Project	IEEE 802.16 Broadband Wireless Access Working Group < http://ieee802.org/16 >	
Title	Modification on Relaying DCD and UCD	
Date Submitted	2007-07-18	
Source(s)	Kanchei (Ken) Loa, Yi-Hsueh Tsai, Yung-Ting Lee, Hua-Chiang Yin, Shiann-Tsong Sheu, Youn-Tai Lee, Institute for Information Industry 8F, No. 218, Sec. 2, Dunhua S. Rd., Taipei City 106, Taiwan	Voice: +886-2-27399616 Fax: +886-2-23782328 loa@nmi.iii.org.tw
Re:	IEEE 802.16j-07/019: "Call for Technical Comments Regarding IEEE Project 802.16j"	
Abstract	This contribution proposes modification on relaying DCD and UCD	
Purpose	Text proposal for 802.16j Baseline Document.	
Notice	<i>This document does not represent the agreed views of the IEEE 802.16 Working Group or any of its subgroups. It represents only the views of the participants listed in the "Source(s)" field above. It is offered as a basis for discussion. It is not binding on the contributor(s), who reserve(s) the right to add, amend or withdraw material contained herein.</i>

Modification on Relaying DCD and UCD

6.3.28.1 RS broadcast message relaying

Figure xxx –Relaying DCD/UCD procedure

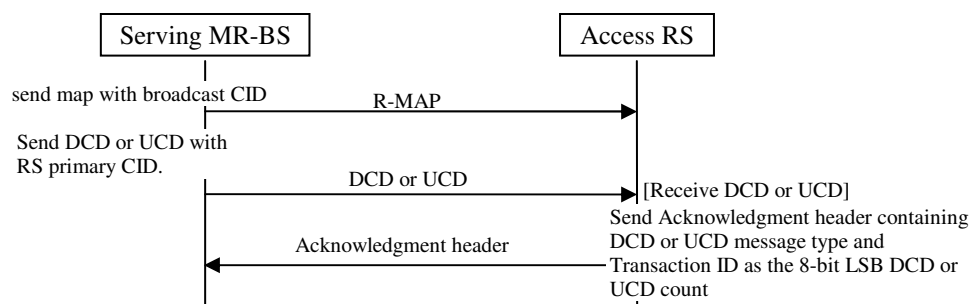
Upon receiving the DCD/UCD message with RS primary CID, as shown in Figure xxx, the RS should acknowledge the reception of DCD or UCD messages over primary management connection by sending an acknowledgment header (See 6.3.2.1.2.2.2.3). The Transaction ID of the ACK header shall be set to the Configuration Change Count of DCD or UCD message. There shall be one ACK header per message. The RS may retransmit DCD/UCD message if ACK header is not received at the expiration of T52 timer.

Figure yyy – DCD/UCD broadcasting with centralized scheduling

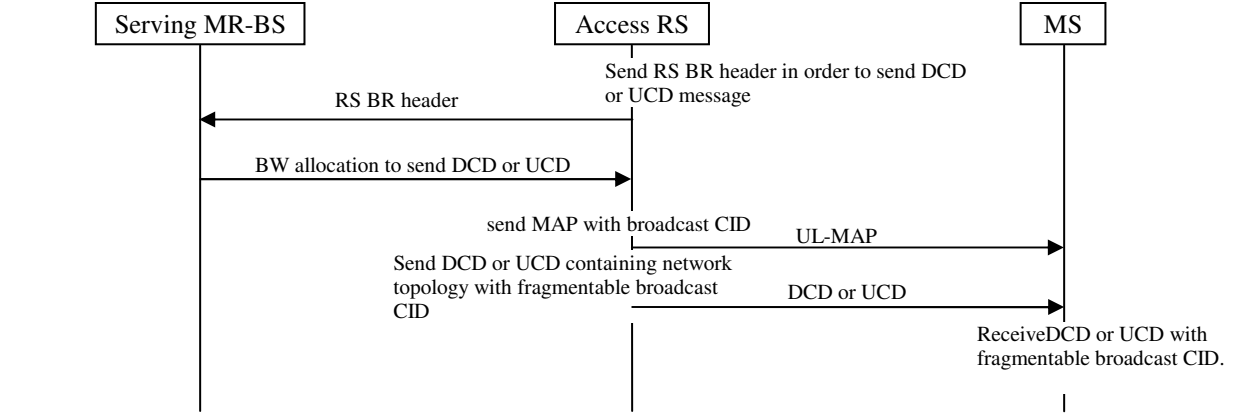
Under centralized scheduling, as shown in Figure yyy, the RS shall request bandwidth on the access link to broadcast the DCD/UCD message with fragmentable broadcast CID.
